*Re: Applications of 45 Hurlingham, LLC for Site Plan, Special Permit, Wetlands Permit  
and Tree Removal Permit Approvals to Construct a New Residence, Caretaker's  
Quarters, Driveway, Tennis Court, Dock and Related Utilities and Improvements  
Property: 45 Hurlingham Drive, Town of North Castle  
Tax Identification No.: Section 102.04, Block 1, Lot 26*

This submission is made to apprise the Board of some changes to the site plan requested by our client, as well as to clarify or provide additional information to address questions and comments raised in the Review Memoranda of the Town Planner dated February 12, 2021 (the "Planning Memorandum") and Consulting Town Engineers, dated February 17, 2021 (the "Engineering Memorandum").

# SITE PLAN REVIEW SET PROPOSED RESIDENCE

**DRIVEWAY PROFILE  
MAIN DRIVE FROM STREET TO DRIVEWAY CIRCLE**

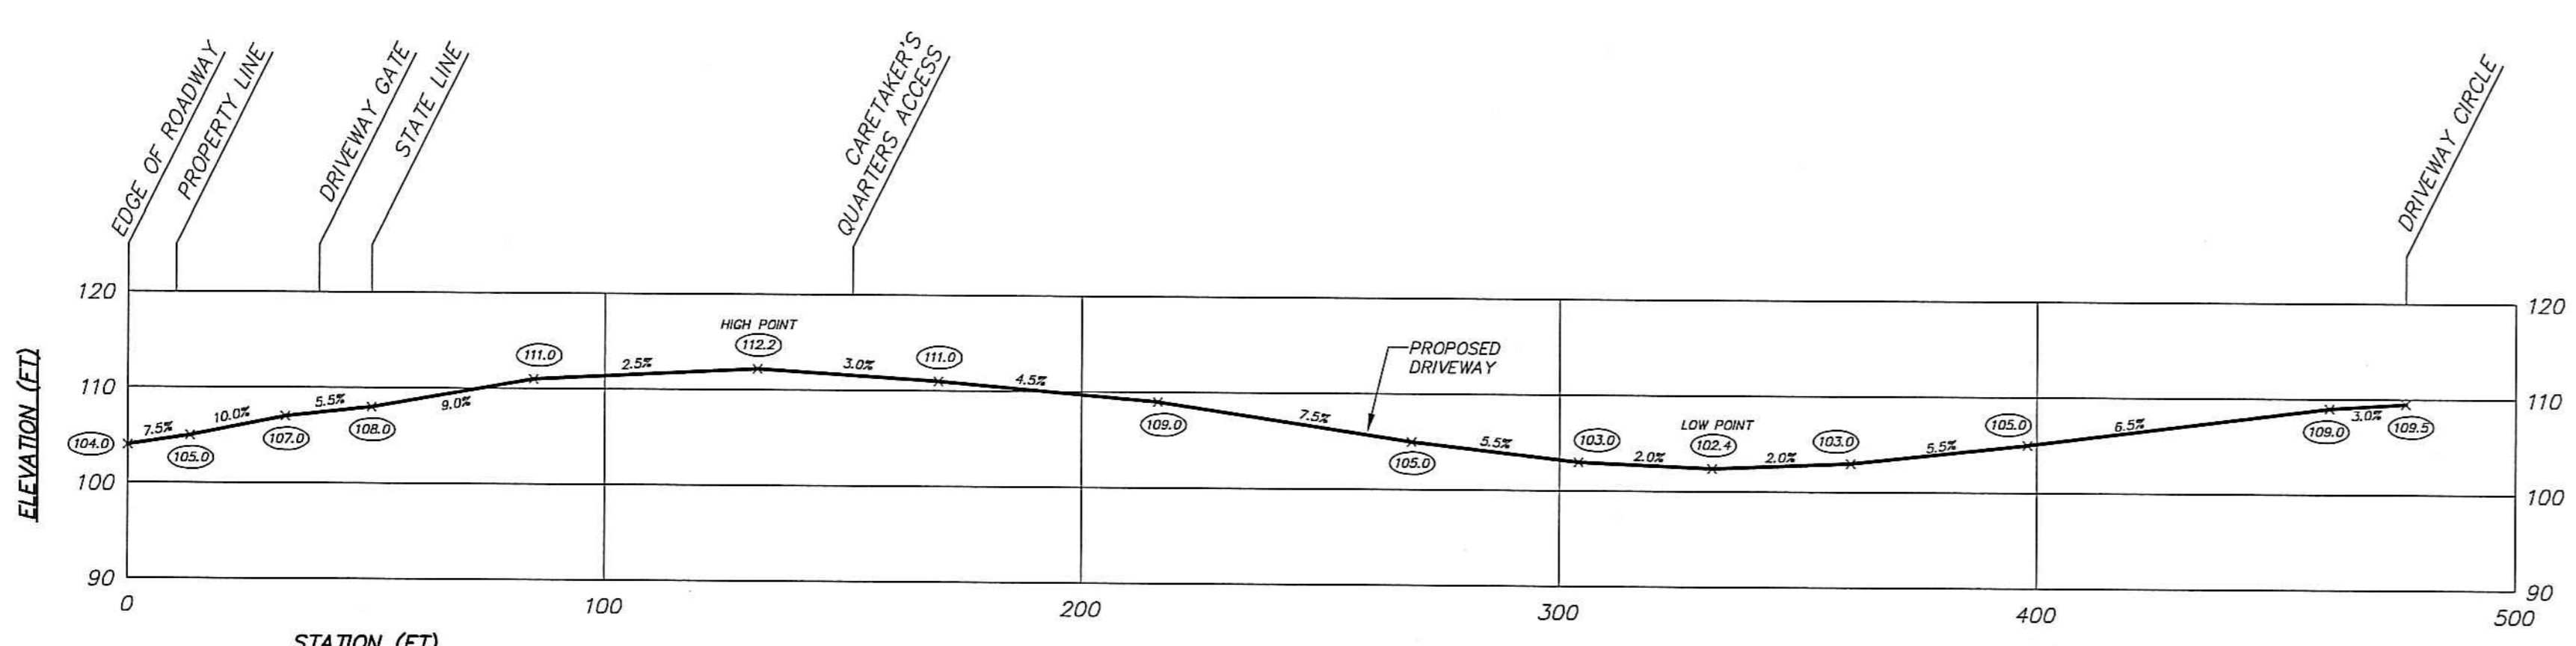
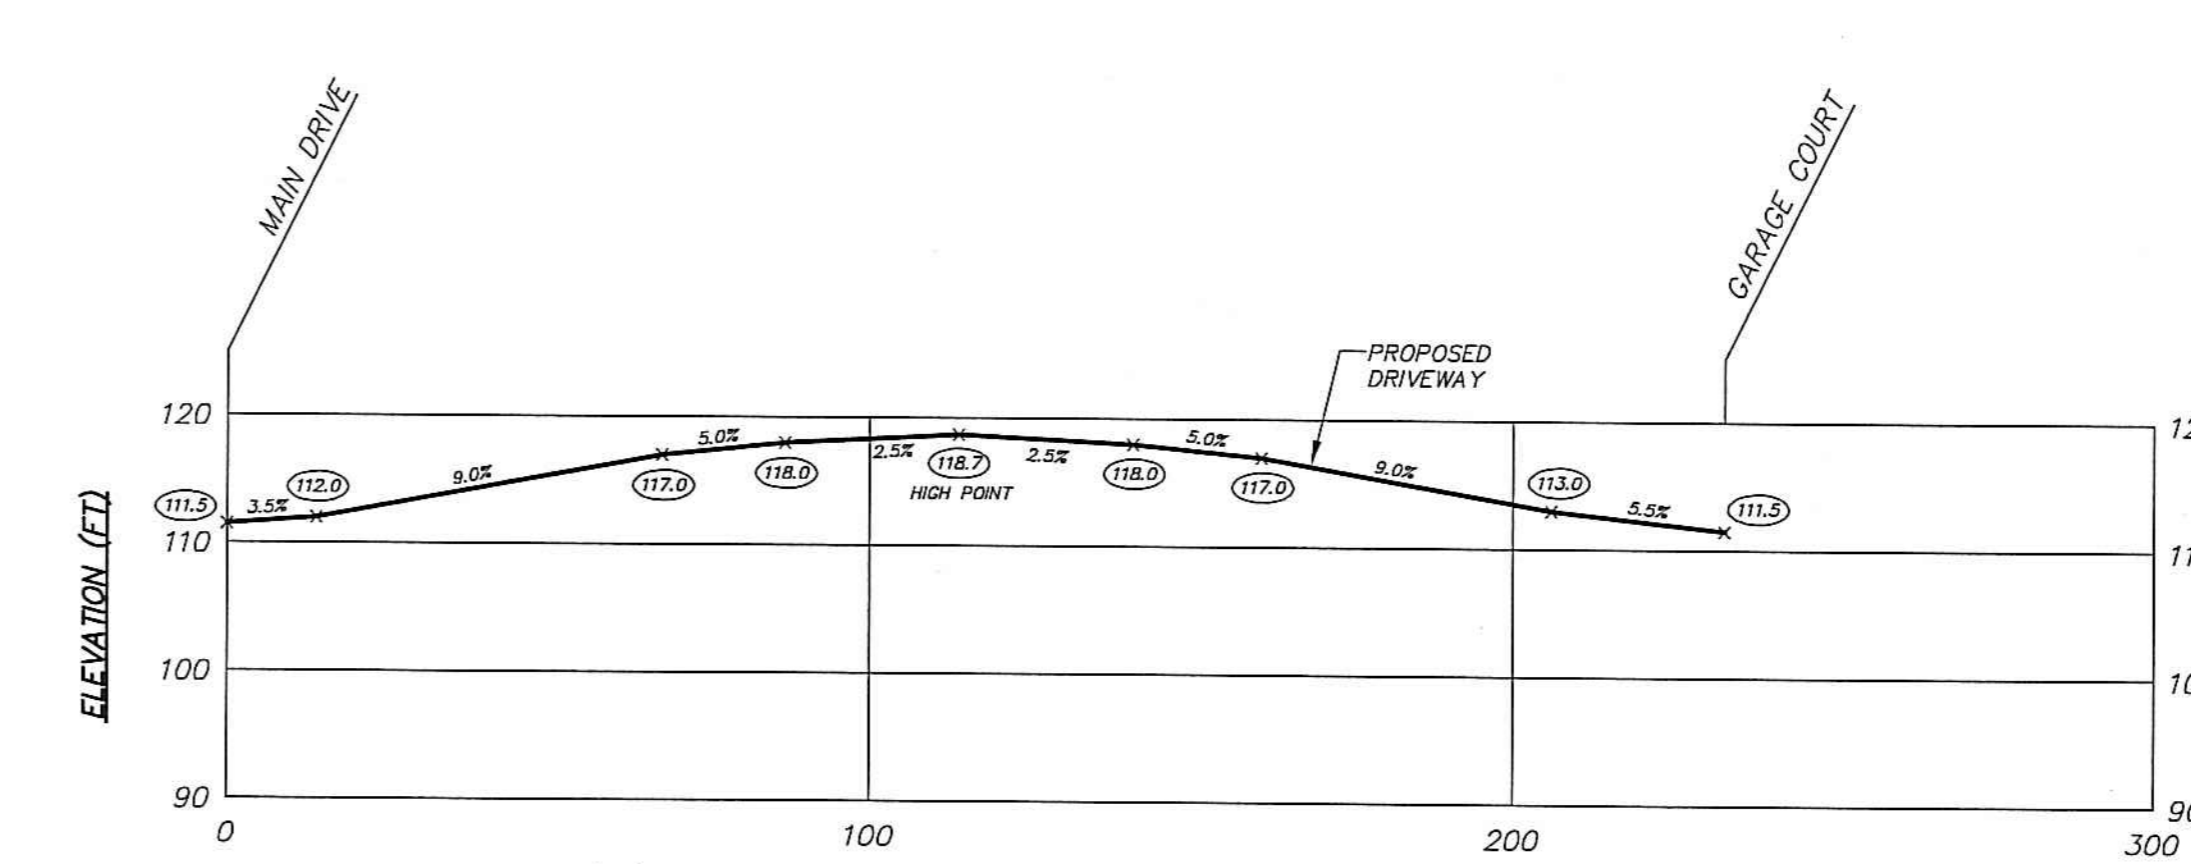
12. The Notes & Details Plan (item 1(a)(v)) has been revised to include a driveway profile with vertical geometry to demonstrate compliance with Section 355-59 of the Town Code.

1 OF 1: **DEVELOPMENT PLAN SHOWING POSSIBLE SUBDIVISION FOR CARETAKER'S QUARTERS**

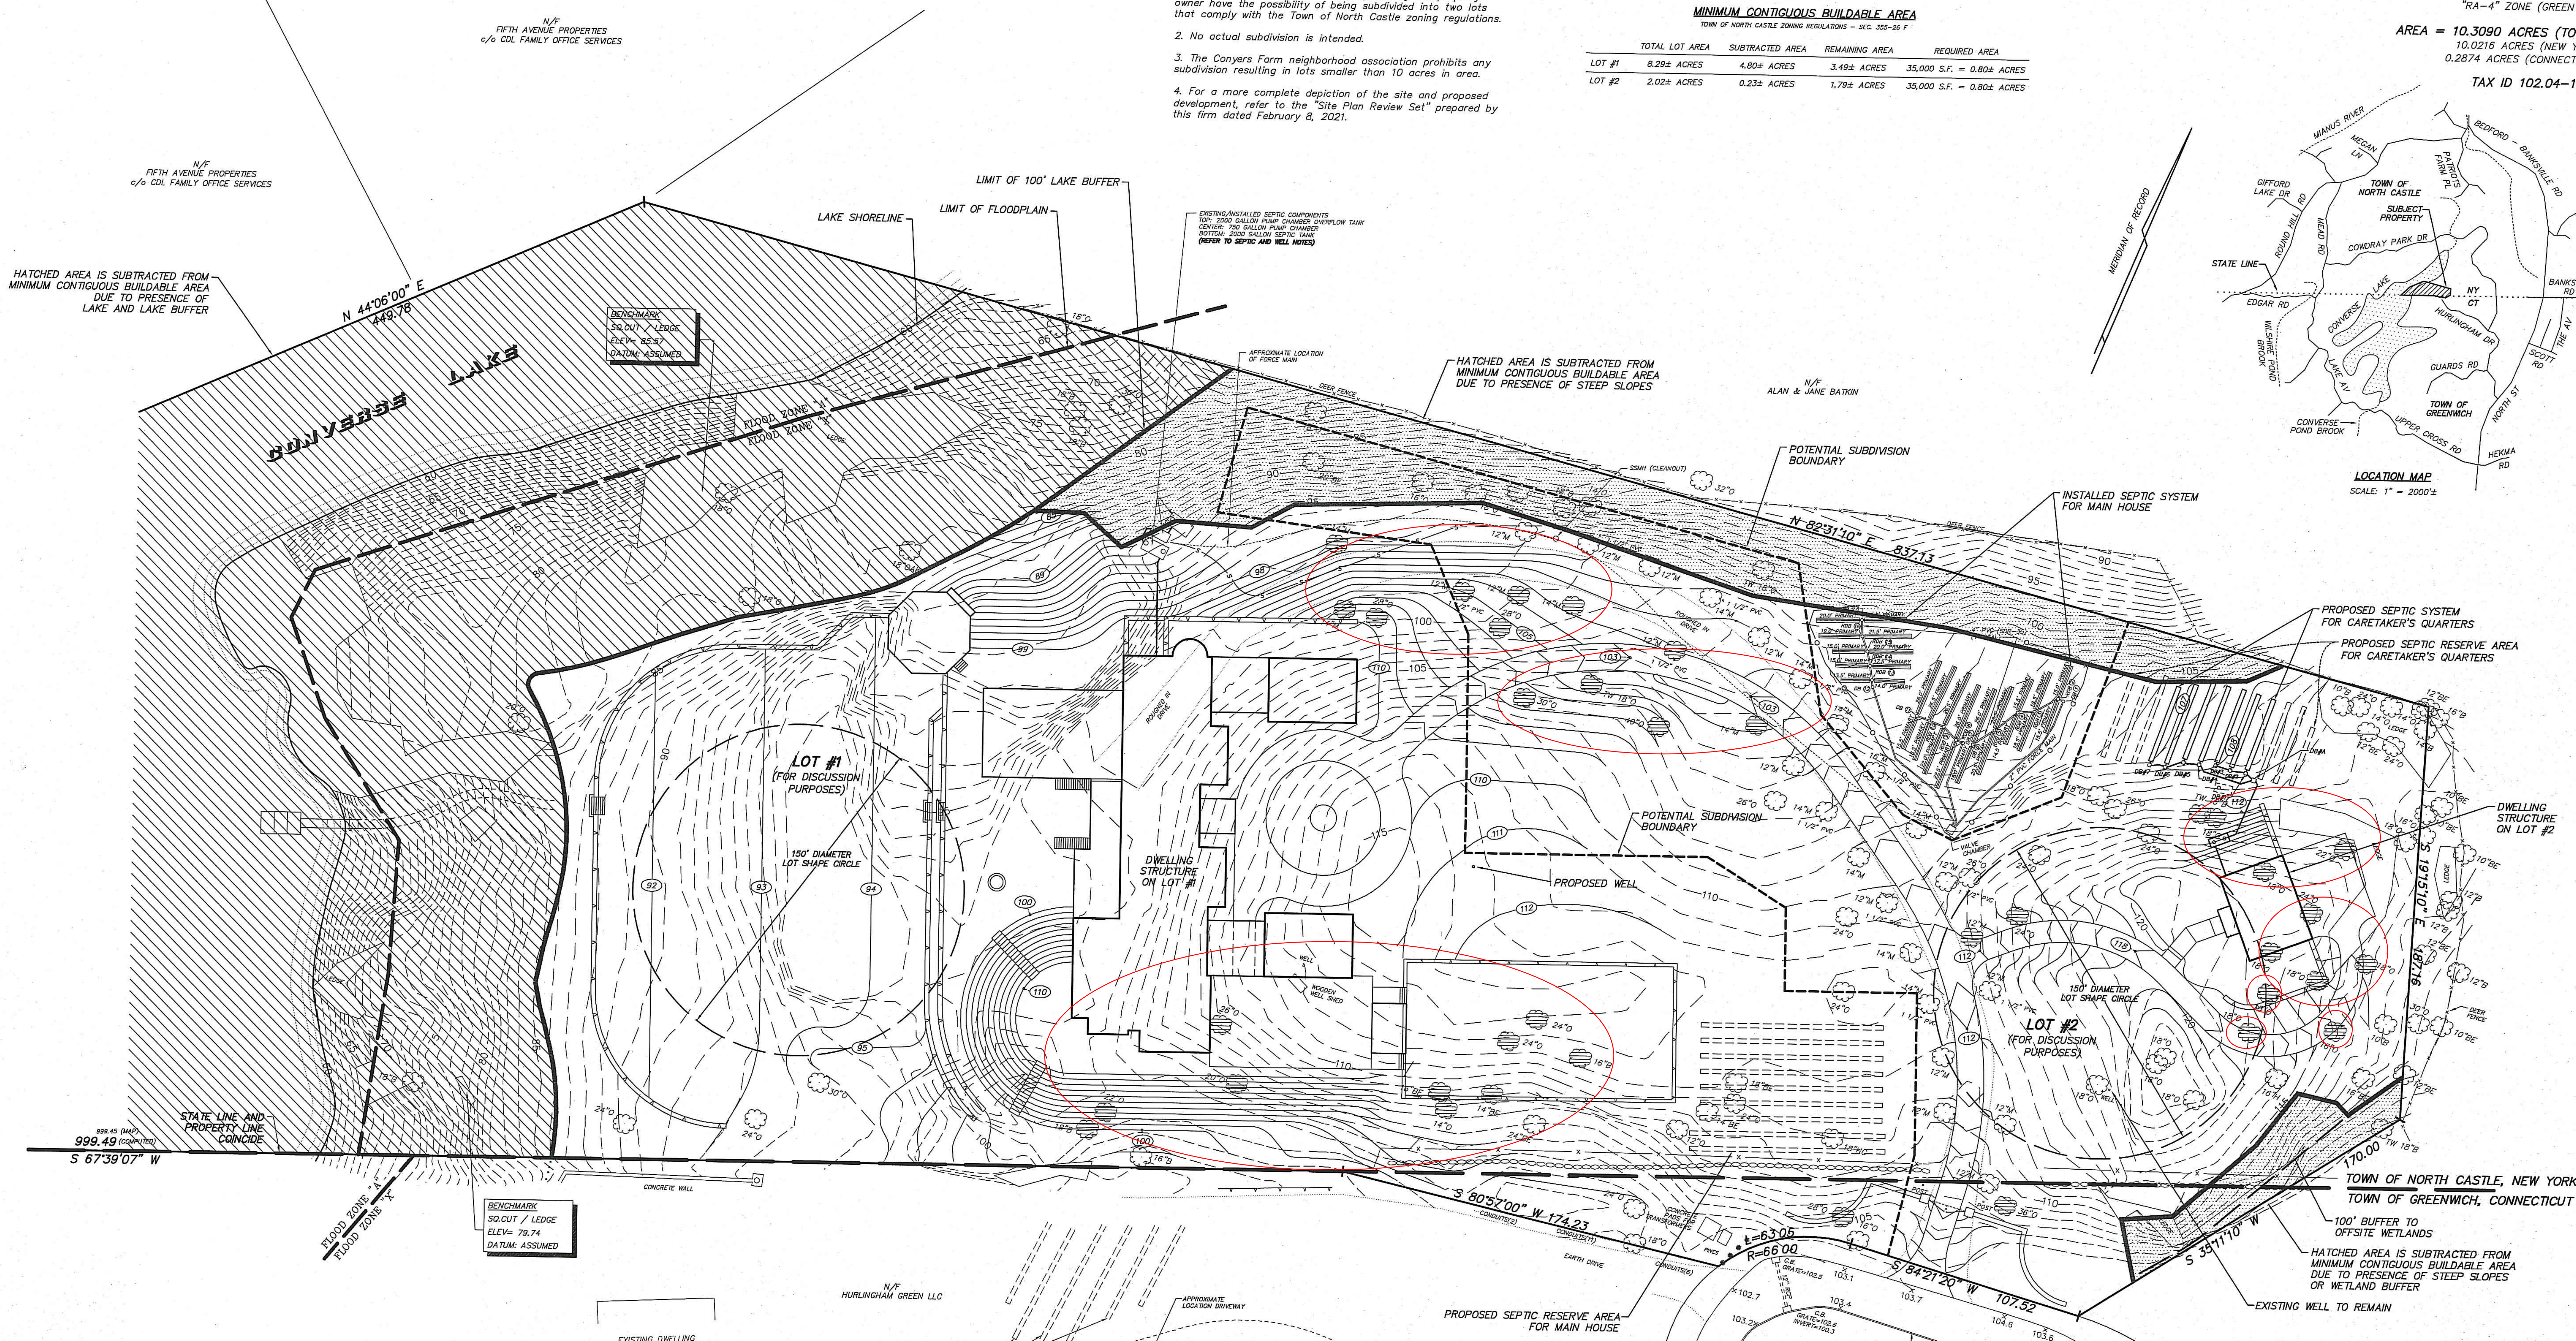
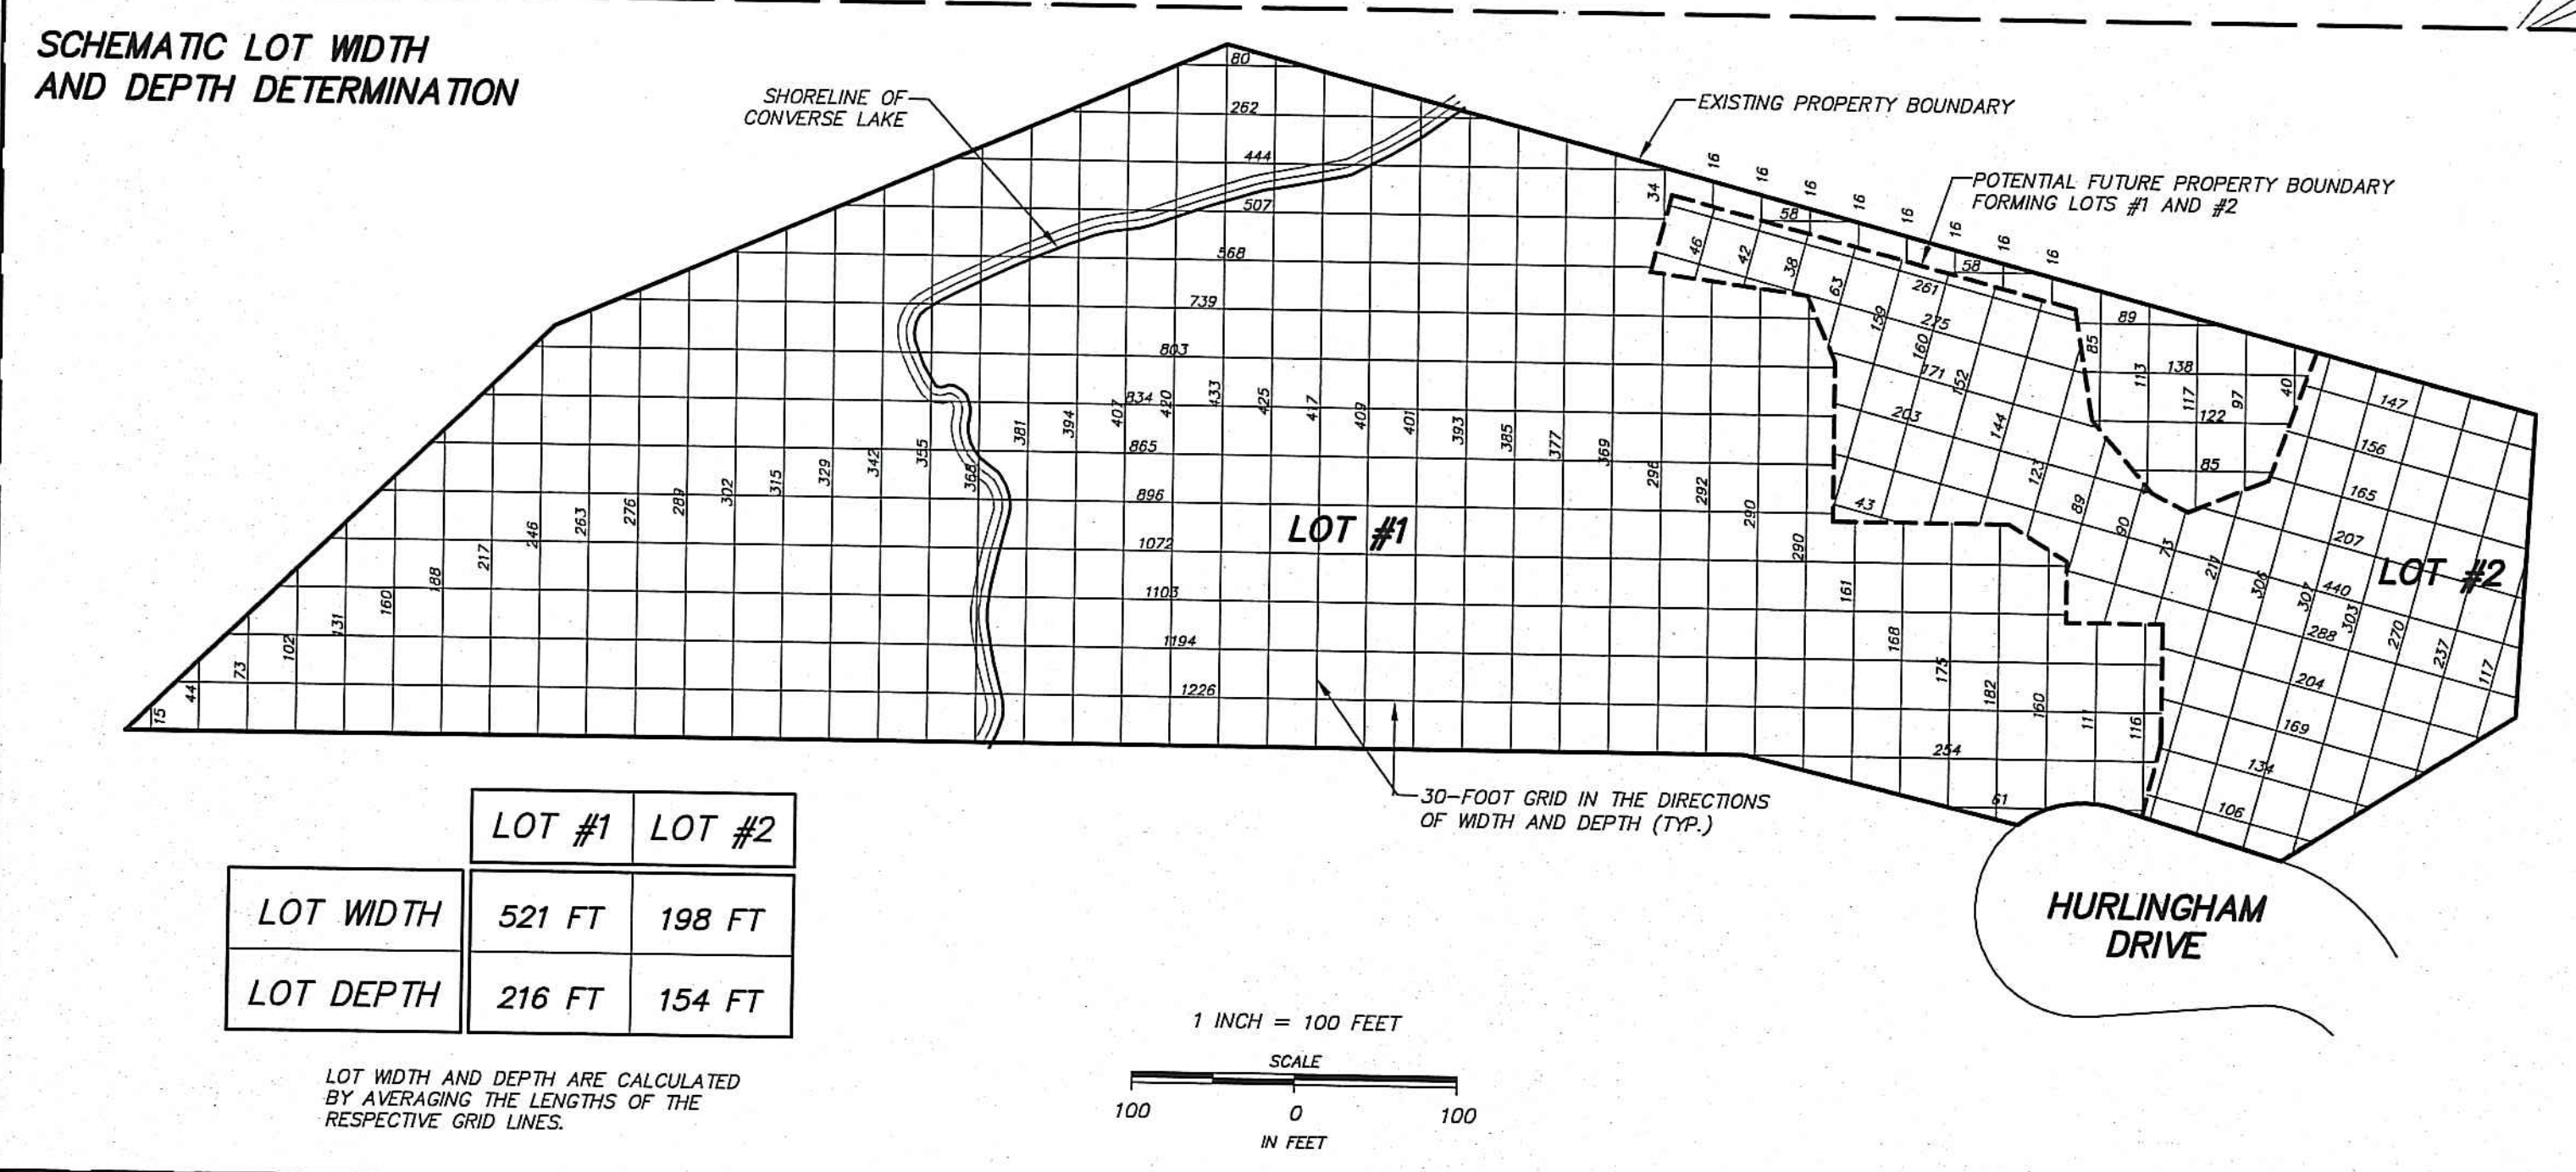
1. The Phantom Subdivision Plan (item 1(d)) has been updated to include a zoning conformance chart showing how each lot conforms with the minimum requirements of the R-2A Zoning District.

1. Revisions to, and supporting documentation for, the Phantom Subdivision Plan (item 1(d)) :
  - a. A Bulk Zoning Conformance Table for both “phantom” lots is included on the revised Phantom Subdivision Plan.

- b. Steep Slopes are depicted on the Phantom Subdivision Plan.
  - c. The Minimum Contiguous Buildable Area for each phantom lot has been added to the Phantom Subdivision Plan.

- d. The depiction of the expansion area for the septic system serving the Caretaker’s Quarters (i.e. Lot 2) has been corrected.
  - e. The private wells have been added to the Phantom Subdivision Plan.
